Site Plan Review Committee (SPRC)
Staff Report for:
YMCA Project (Site Plan #SPLN22-00005)

YMCA Project (SP #SPLN22-00005)
(RPC#s 15-086-022, -023, -024)

Figure 6: Circulation and Public Space Concept Map

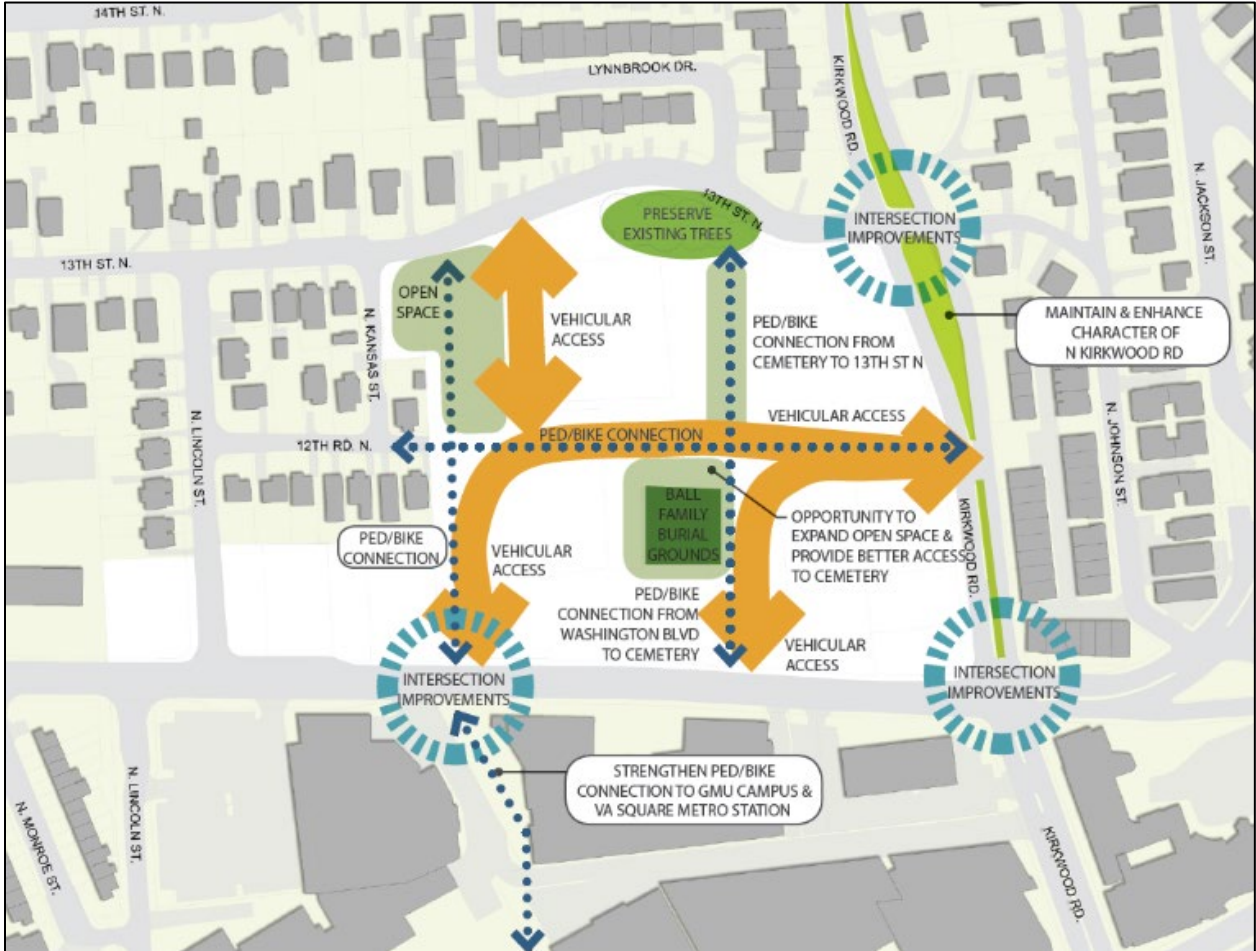
Site Circulation: The Circulation and Public Space Concept Map (Figure 6) recommends a new network of public vehicular, bicycle, and pedestrian streets or alleys, and recommends new general locations for new or enlarged public open spaces. Notes on the Circulation Concept Map advise that the map is “conceptual only and final locations of all elements will be determined with final site plan approval” and that the “creation of new streets providing vehicular access may need to be phased over time, and segments located along shared property lines may be achieved one-half at a time, concurrent with respective redevelopment projects.” The GLUP Study recommends that the typology of new public street connections be either an Alley, Shared Street, or Pedestrian Priority Street. Of the street typologies discussed in the GLUP Study, only the Pedestrian Priority Street represents a typology that may not necessarily provide vehicular access. The MTP identifies this street as one appropriate in locations where it will not unduly affect vehicular traffic in the surrounding area, and *pedestrian priority streets may also accommodate other public space amenities, such as seating and landscaping provided that a travel corridor and direct visual access between adjacent streets is maintained.*

New Kansas Street: As noted previously, the County Board has approved interior vehicular connections with alternative paver treatments and staff recommends that this design treatment continue with respect to materiality, dimensions, and alignment. The north-south New Kansas Street connection from 13th Street would function as the vehicular connection linking the YMCA building to Washington Boulevard as envisioned in the GLUP Study. However, the proposed alternative paver treatment is inconsistent with prior approvals and the design appears intended to function as both a street connection and an extension of the public space along Kansas Street, while not satisfying the full needs of either element. The street section is less in total width than what is provided in the Terwilliger Place development to the south, and does not provide for a consistent pedestrian path through to 13th Street, instead effectively ending at the entrance to the parking garage and loading bay.

East-West Connection: The proposed variable width path running east-west through the site, in place of a street, is inconsistent with the GLUP Study and MTP guidance. As noted previously, pedestrian priority street typologies do permit connections limited to pedestrian and bicycle traffic; however, the proposed design does not meet the broad guidance outlined in the MTP for this street typology. Staff has identified several recommendations for the applicant to consider in order to meet expectations for this street typology and the connectivity envisioned in the GLUP Study. Those include the use of alternative pavement material, street lighting structures, a minimum 15-foot pavement width, and total width of 40-50 feet for the corridor – which would accommodate full tree planting zones on both sides of the street connection. Further, staff has also called for a wider building separation and separating the path from the building, to accommodate a north-south bike/ped connection from 13th Street that will visually read as a public path connection. In addition to MTP guidance for pedestrian priority streets, staff has encouraged the applicant to look at strategies to create a linear public space consistent with examples from the GLUP Study and existing paths in Arlington that are located between residential neighborhoods or development, such as the Fillmore Park Trail or the Bluemont Junction Trail.

Figure 9: Special GLUP Study Tree Canopy Coverage

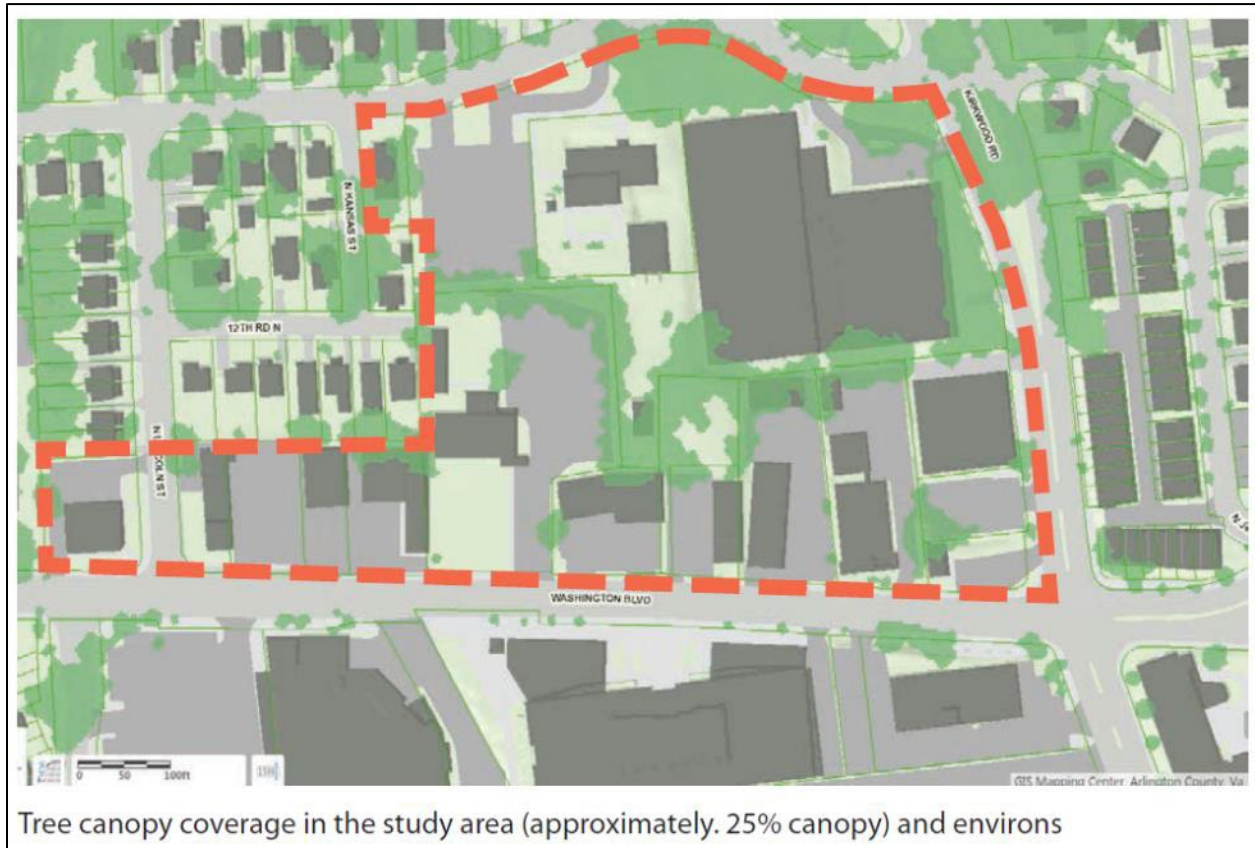
The Special GLUP Study calls for maintaining the approximately 25% tree canopy coverage that exists across the study area today (shown in Figure 9 above), specifically noting that *“future tree canopy coverage should remain at or even exceed 25%, given the opportunities for new street trees and open space improvements, combined with existing canopy preservation goals.”* This recommendation is an average that does not prescribe coverage to any one site, with the expectation that individual sites meet or exceed their existing coverage. The applicant’s proposed tree canopy for the subject site is approximately 23.8%; however, existing tree coverage is not identified at this time. Recently, the Mill Street Residential project was approved with a tree canopy coverage of approximately 14%, while the Terwilliger Place project was approved with a tree canopy coverage of approximately 13.6%.
